## Groundwater Application Review Summary Form

Application # G- 18829

GW Reviewer Travis Brown Date Review Completed: 7/31/2019

TO: Water Rights Section Date 7/31/2019  
 FROM: Groundwater Section Travis Brown  
 Reviewer's Name  
 SUBJECT: Application G- 18829 Supersedes review of \_\_\_\_\_  
 Date of Review(s)

### Hydrographs

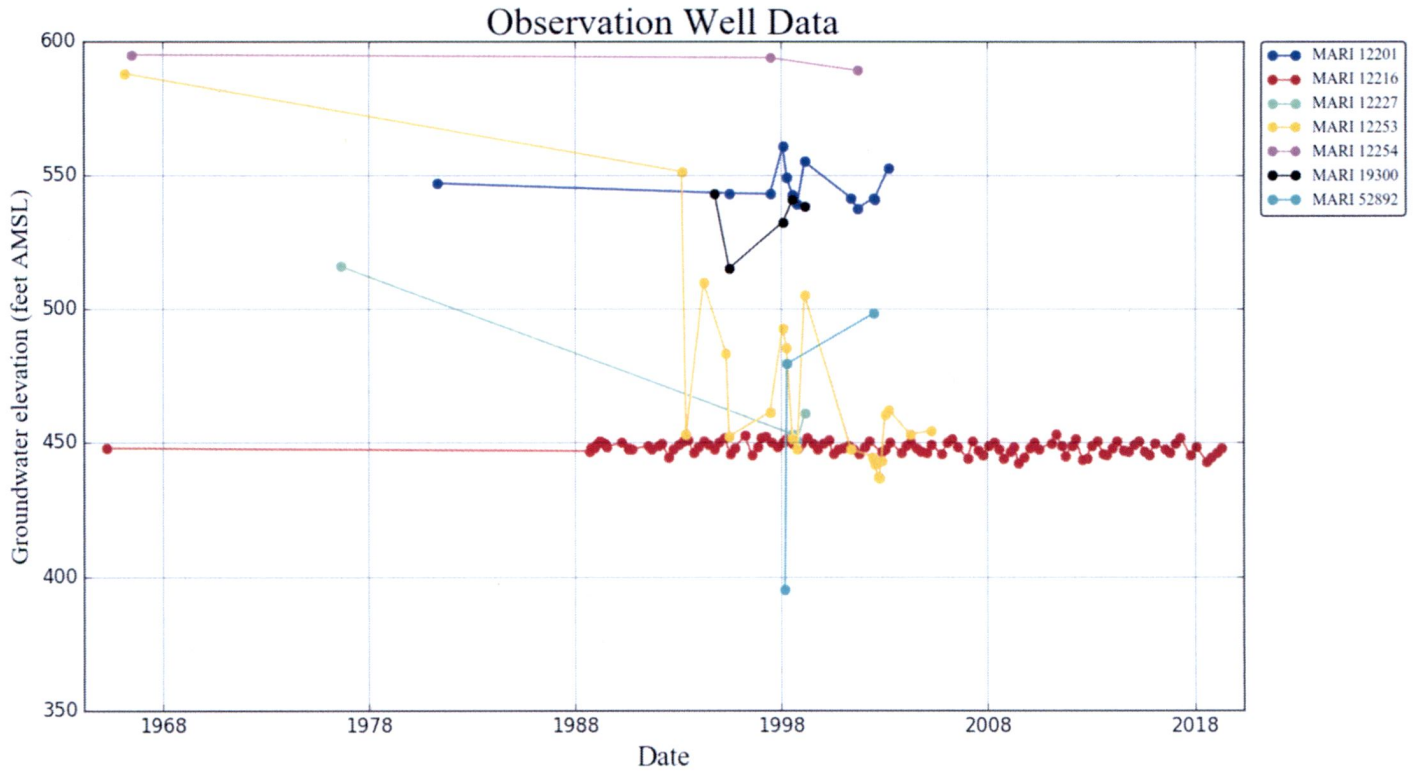
Long-term water level data are primarily available for wells located near or on the far side of normal faults mapped by Tolan and Beeson (2000). These data indicate varied water level trends, though most wells show only moderate water level declines over time (see attached Hydrograph). However, statistical analysis of water wells completed in Sections 20 and 21 of Township 8 South, Range 3 West indicate a trend of deepening well completions over time, as well as a trend of lower static water levels (SWLs) with deeper well completions (see Well Statistics – 8S/3W S20 & S21, attached). There is also some indication of deeper initial reported SWLs over time. These trends may be a consequence of dropping water levels in the aquifer. There is some uncertainty that the groundwater resource can sustain the proposed use of 0.17 cfs (~76 gpm); median reported well yield in Sections 20 and 21 is 20 gpm (~0.04 cfs), ~26 percent of the requested use (see Well Statistics - 8S/3W S20 & S21, attached). However, the maximum reported yield in these sections is 300 gpm (0.67 cfs).

**Theis Drawdown Analysis**

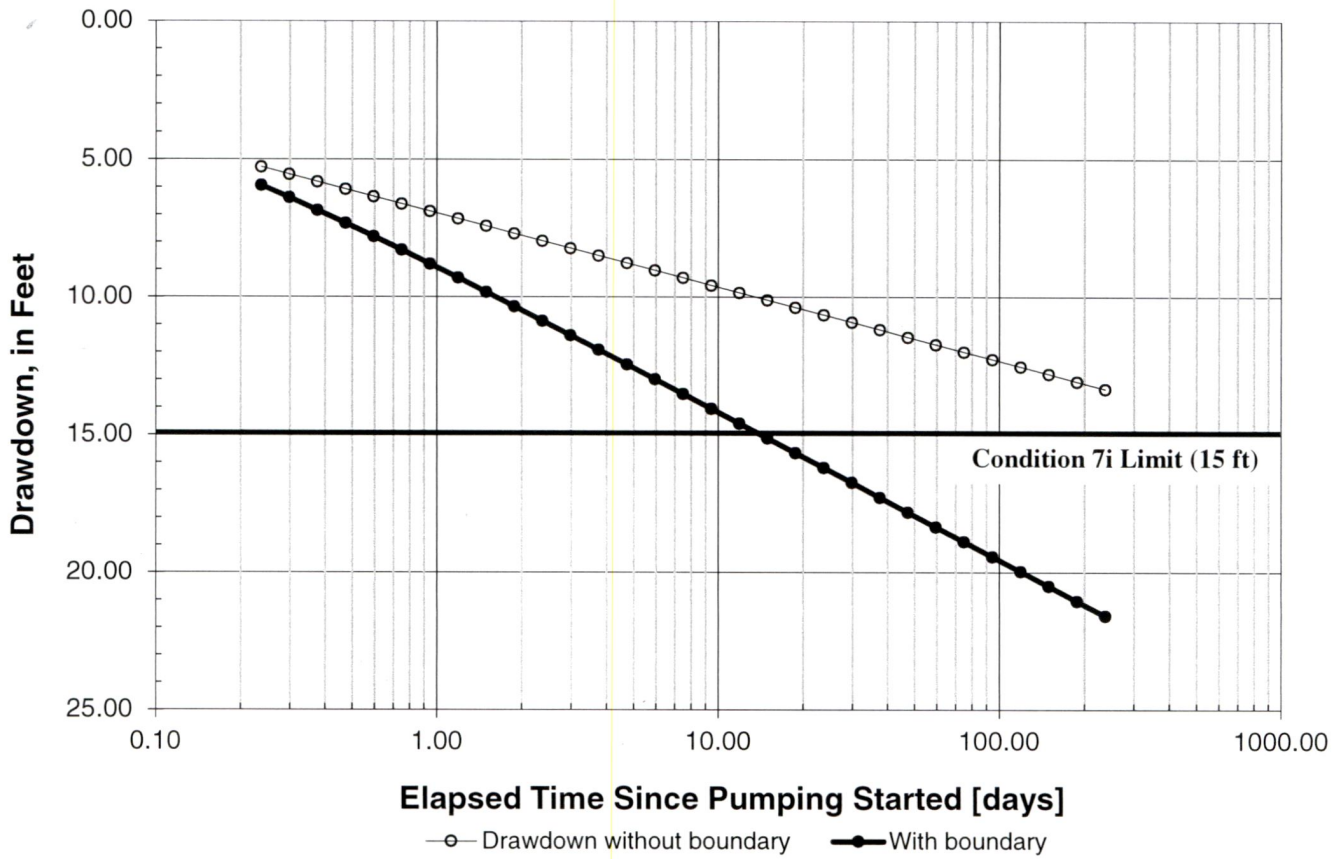
The nearest groundwater user (MARI 58051, an exempt domestic well) is ~290 ft northwest of the proposed POA location. **The location of MARI 58051 was not available at the time of approval for LL-1597.** MARI 58051 is completed to a depth of ~283 ft bls and has open annular space from ~151-283 ft bls. Although well construction information was not specified for the proposed POA, it is likely the proposed use would cause some degree of well-to-well interference with MARI 58051. To assess the degree of drawdown, a Theis drawdown analysis was conducted for the proposed use (see attached Theis Drawdown Analysis). **Results indicate that the proposed use could cause well-to-well interference with MARI 58051 to exceed 15 ft of drawdown within approximately 2 weeks of continuous operation, which would require curtailment of the proposed use per Condition 7i, above. Therefore, it would appear that groundwater for the proposed use will not likely be available in the amounts requested without injury to prior water rights.**

The degree of compartmentalization due to nearby faults, which is unknown at this time, may exacerbate well-to-well interference and longer term water level declines in the local basalt aquifer. To protect existing users, the following **Special Conditions** are recommended for any permit issued pursuant to this application.

2. The well shall be continuously cased and continuously sealed to at least 175 feet below land surface, or as approved by a Department hydrogeologist during the drilling process.

3. The well shall be open to a single aquifer in the Winter Water Unit of the Grande Ronde Basalt Formation in the Columbia River Basalt Group and shall meet applicable well construction standards (OAR 690-200 and OAR 690-210). In addition, the open interval shall be no greater than 100 feet. However, a larger open interval may be approved by the Department if the applicant can demonstrate to the satisfaction of the Department that each well is only open to a single aquifer. Following well completion, the well shall be thoroughly developed to remove cuttings and drilling fluids. Substantial evidence of a single aquifer completion may be collected by video log, downhole flowmeter, water chemistry and temperature, or other downhole geophysical methods approved by the Department. These methods shall characterize the nature of the basalt rock and assess whether water is moving in the borehole. Any discernable movement of water within the well bore when the well is not being pumped shall be assumed as evidence of the presence of multiple aquifers in the open interval.
